# **Review and Evaluation of the Bright Mountain Solar, LLC Site Assessment Report**

**Kentucky Public Service Commission and  
Kentucky State Board on Electrical Generation and  
Transmission Siting**

**January 12, 2024**

**Re: Harvey Economics' Review of Bright Mountain Solar, LLC's Site  
Assessment Report for Solar Facilities in Perry County, Kentucky**

**Exhibit 3-1.**  
**Location, Overview and Project Facilities Map for the Proposed Bright Mountain Solar Project**

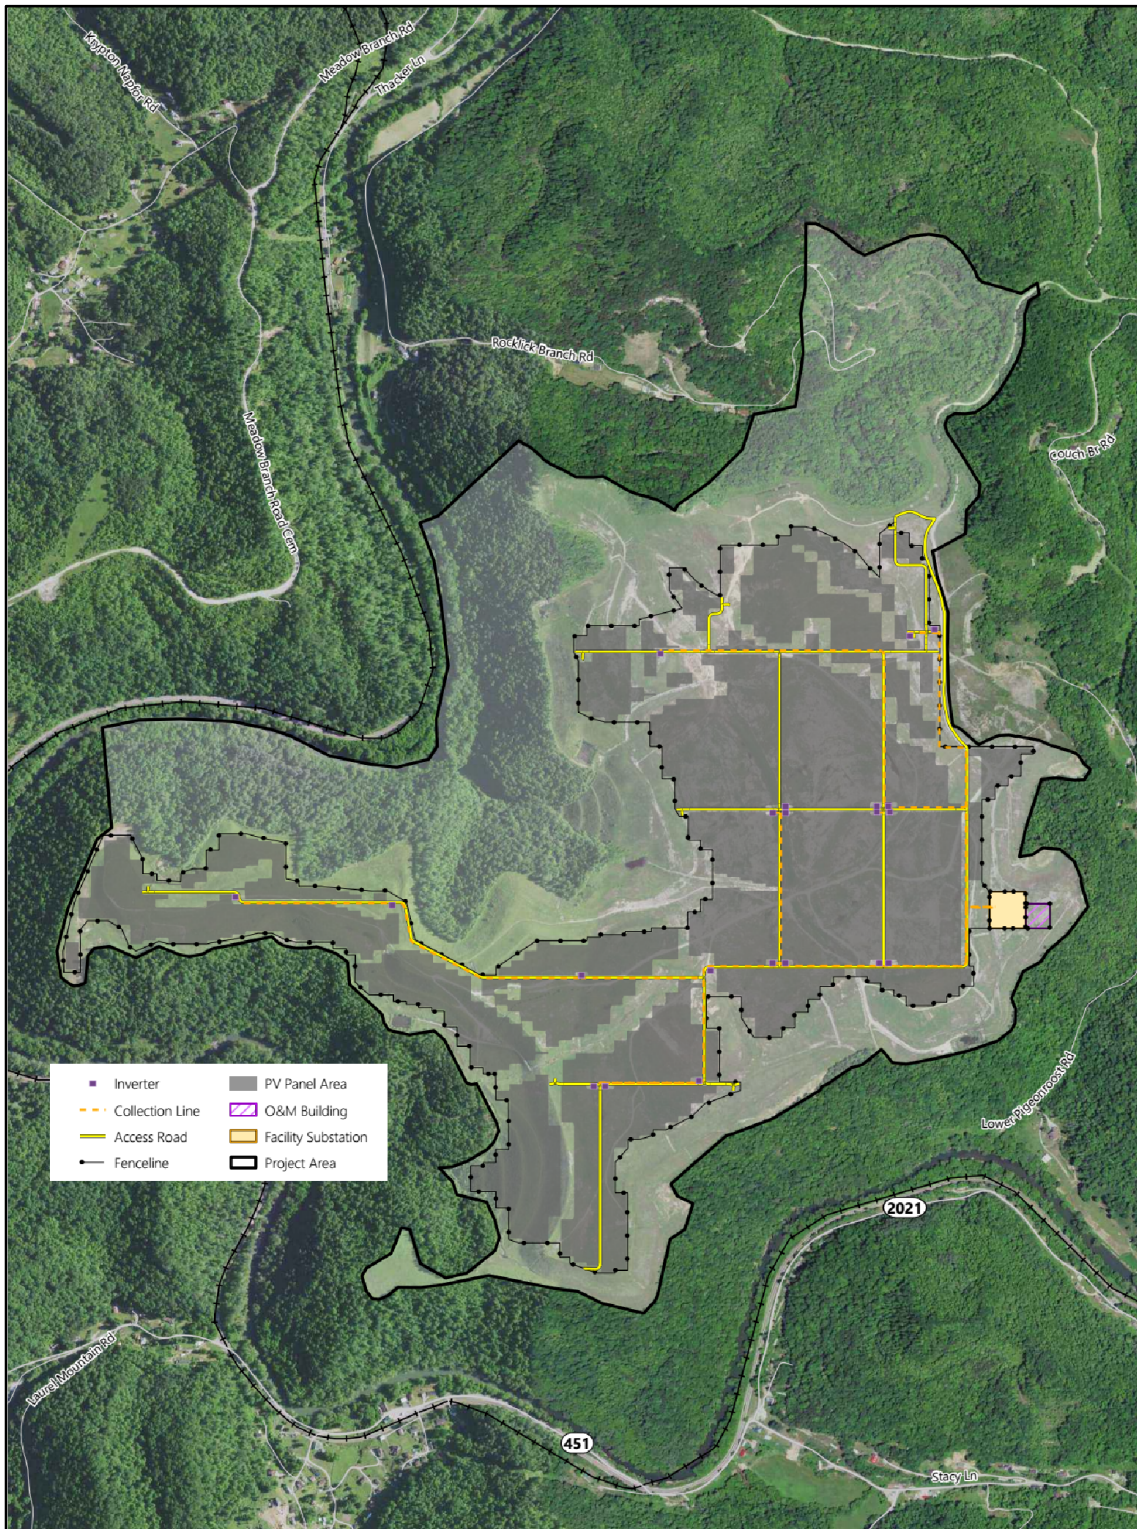
- We believe that the Applicant has generally complied with the legislative requirements for describing the facility and a site development plan, as required by KRS 278.708.
- Security and access control measures appear to be adequate, given the type of facility and its location in a rural area.
- The Bright Mountain Solar Project does not meet the existing setback requirements, so the Applicant has submitted a motion for a deviation from those requirements. HE believes that the Project, as proposed, does meet the specific statutes noted for consideration in a setback deviation, assuming the mitigation HE proposes is adopted. The Siting Board will need to judge the quality of the Applicant responses in the setback deviation request.

1. A final site layout plan should be submitted to the Siting Board upon completion of the final site design. Deviations from the preliminary site layout plan, which formed the basis for HE's review, should be clearly indicated on the revised graphic. Those changes could include, but are not limited to, the location of solar panels, inverters, transformers, substation, operations and maintenance building or other Project facilities or infrastructure.

2. Any change in Project boundaries from the information which formed this evaluation should be submitted to the Siting Board for review.
3. Details of the final Project transmission line route, including final locations of transmission line structures and distances from nearby residences, should be submitted to the Siting Board upon completion. Deviations from the proposed route, which formed the basis for HE's review, should be clearly indicated.

**Exhibit 3-2.**  
**Proposed Bright Mountain Solar Project's Electric Transmission Line Route**

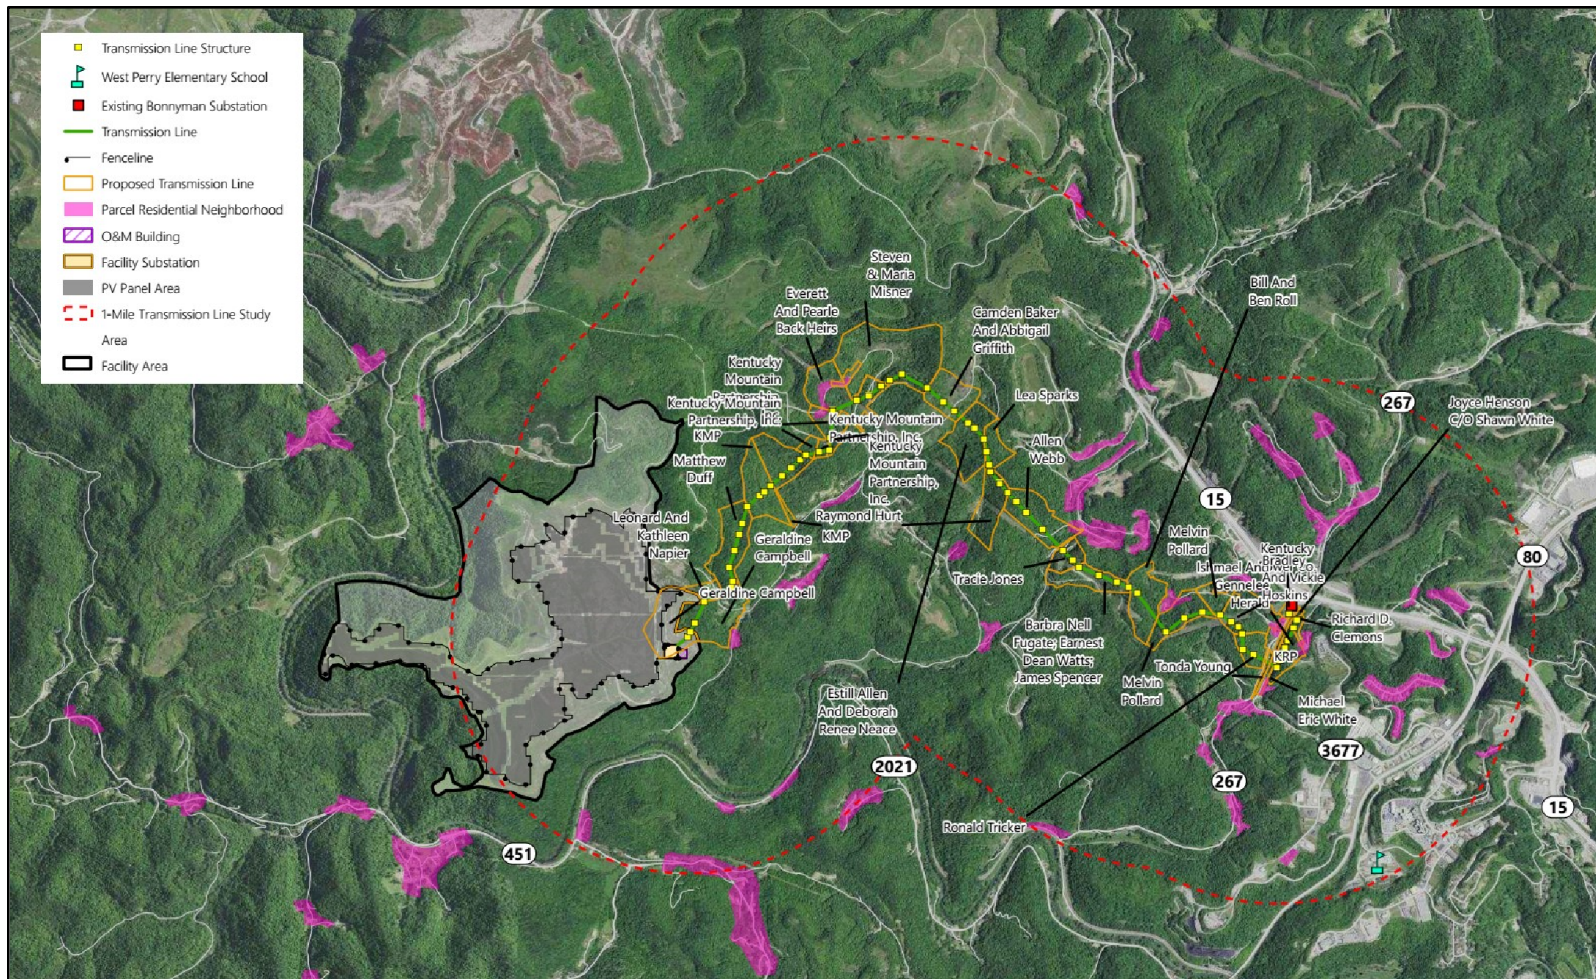
<sup>7</sup> The Applicant has indicated that the final locations of transmission line structures are subject to further engineering design.

### Exhibit 3-3. Preliminary Construction Schedule for the Proposed Bright Mountain Solar Project

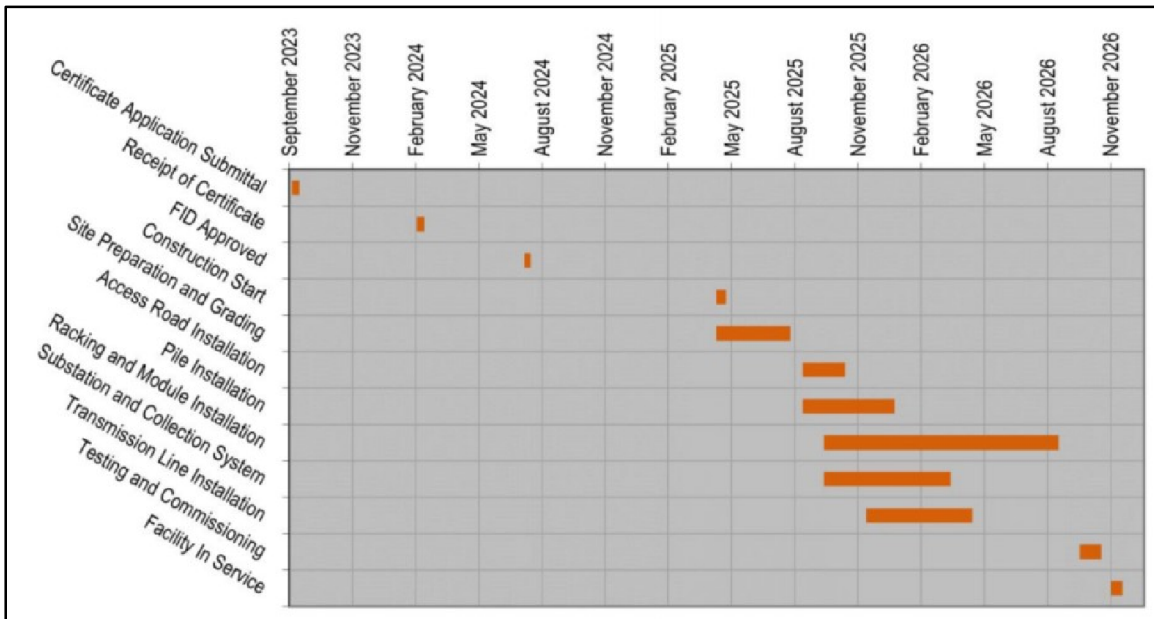
Construction of the Bright Mountain Solar facility is expected to occur over a period of about 16 months, as shown in Exhibit 3-3. Peak construction activity is anticipated to occur during the period in which access road installation, pile installation, racking and module installation, and substation construction would overlap; that period is anticipated to last approximately two to three months.

5. A final, Project-specific, construction schedule, including revised estimates of on-site workers and commuter vehicle traffic, should be submitted to the Siting Board. Deviations from the preliminary construction schedule should be clearly indicated.
